**RE: Objection to SSD-76927247 knowns as the Timberyards by RTL Co. Marrickville**

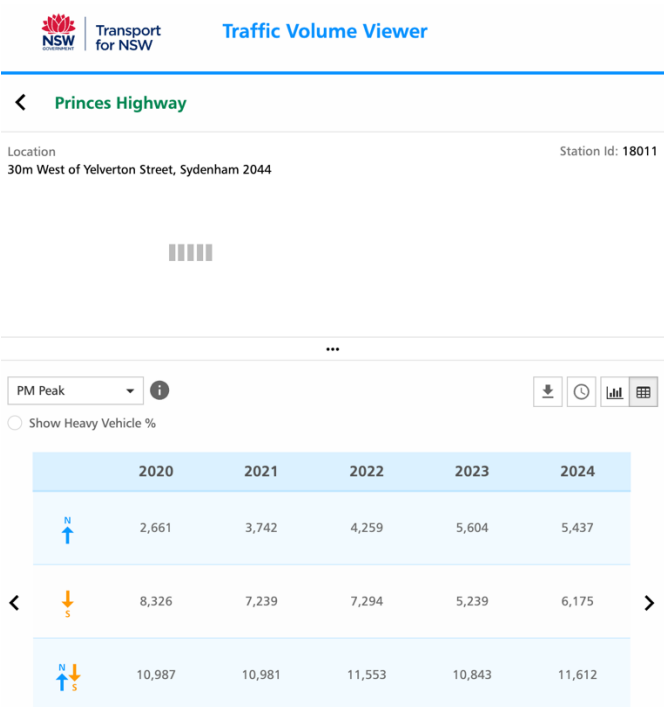
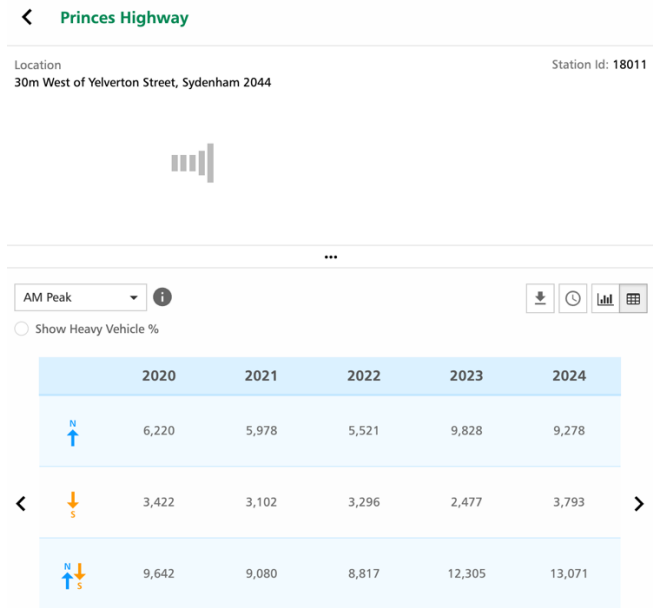
Additionally, the breaching of the height controls on Sydenham Rd and Farr St is unwarranted. In what way can a breach of control by over 150% ever be considered reasonable? And why is it placed in the location where it leads to the most impact to existing residential (single and two storey) homes when there are other suitable location well below the OLS of RL51? Attention should be given to SEARs 6 Environmental Amenity which notes that a **high level of environmental amenity for any surrounding residential** or other sensitive land uses **must be demonstrated**. The proposal leads to significant visual impact ('irreversibly dominant' as per the assessment), and overshadowing to the extent that surrounding residential households will end up with half an hour of sun. This is below the NSW guidelines for residential dwellings for solar access. Furthermore, it will leave a scar on the character of Sydenham Rd where an 8 storey building will be interfaced with a single storey house – this will be the legacy should the development be approved.

**Figure 4.8: PMF Hazard**

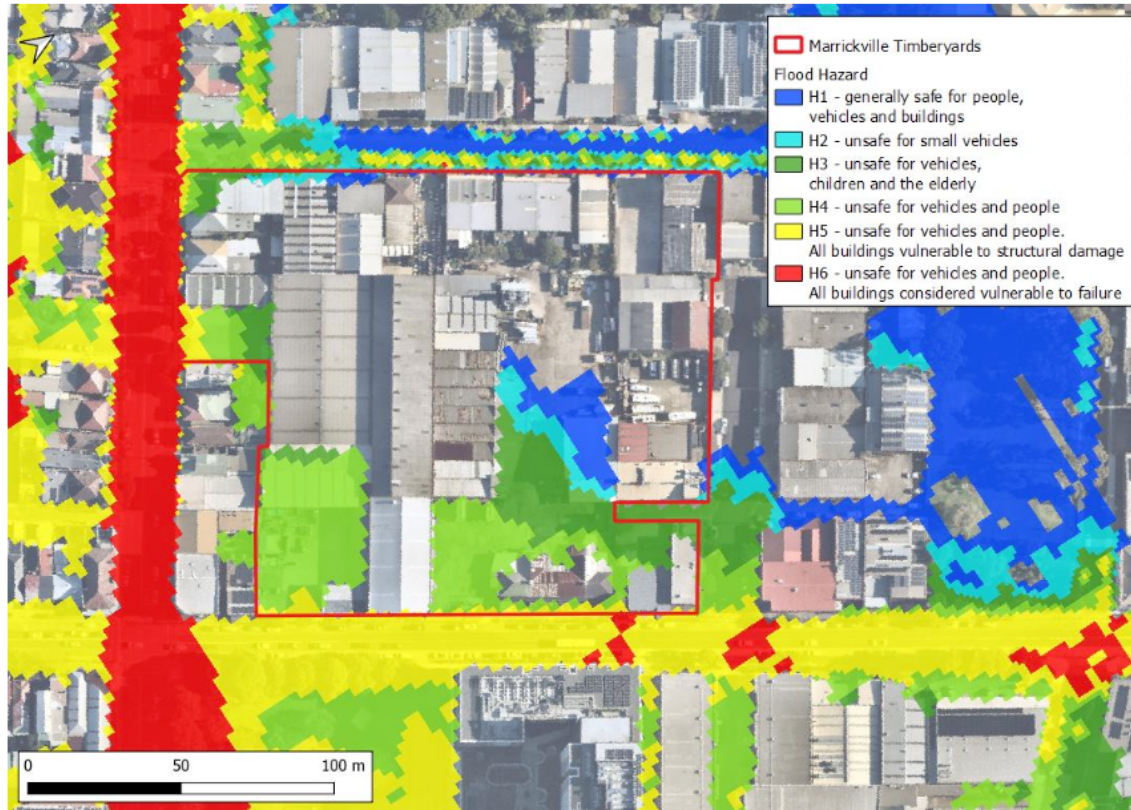
- Assessment is flawed as it does not acknowledge the fact that the site is within the FPA.
  - Innerwest LEP 2022 clauses 5.21 and 5.22 apply and require the assessment of the proposal
- As shown in the 1% AEP and PMF - several buildings are situated in H3 and H4 - Building D, Gateway, Building G, Commerce Lane, Building B

- a. This has severe potential impacts to properties and life downstream as the proposed design does not take into account the 'actual' flooding and will accelerate flooding through surface runoff and unknown impacts to stormwater drainage infrastructure.
